RE: Lyons Quarry, Permit No. M-1977-141, Technical Revision No. 5 (TR-05), Adequacy Review No. 3

RE: Lyons Quarry, DRMS File No. M-1977-141;
TR-5, Review of June 2021 Adequacy Response

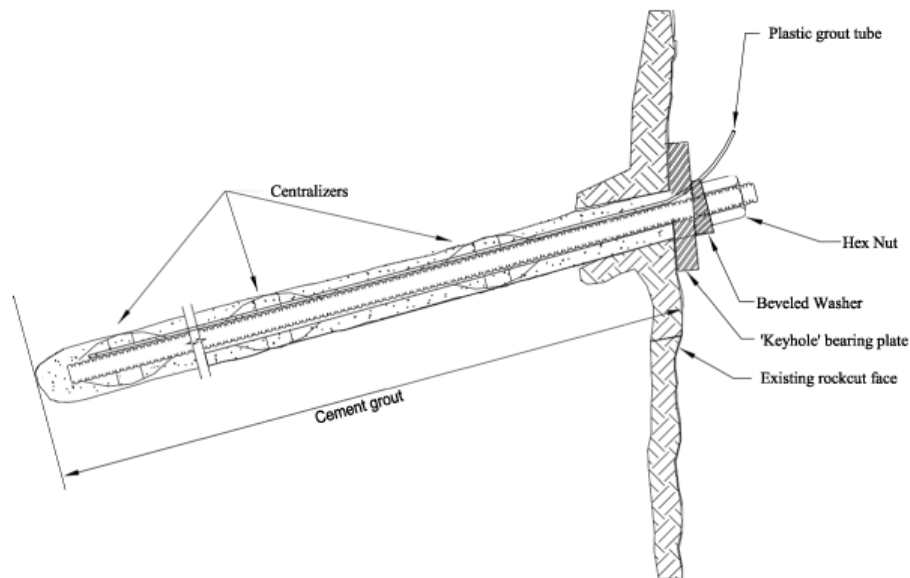
- ix. Anchor bolt detail: The DRMS would expect a rock anchor detail is not premature at this time given the stereonets and rock strengths in the Kleinfelder report. An additional detail similar to the FHWA detail below should be included as well
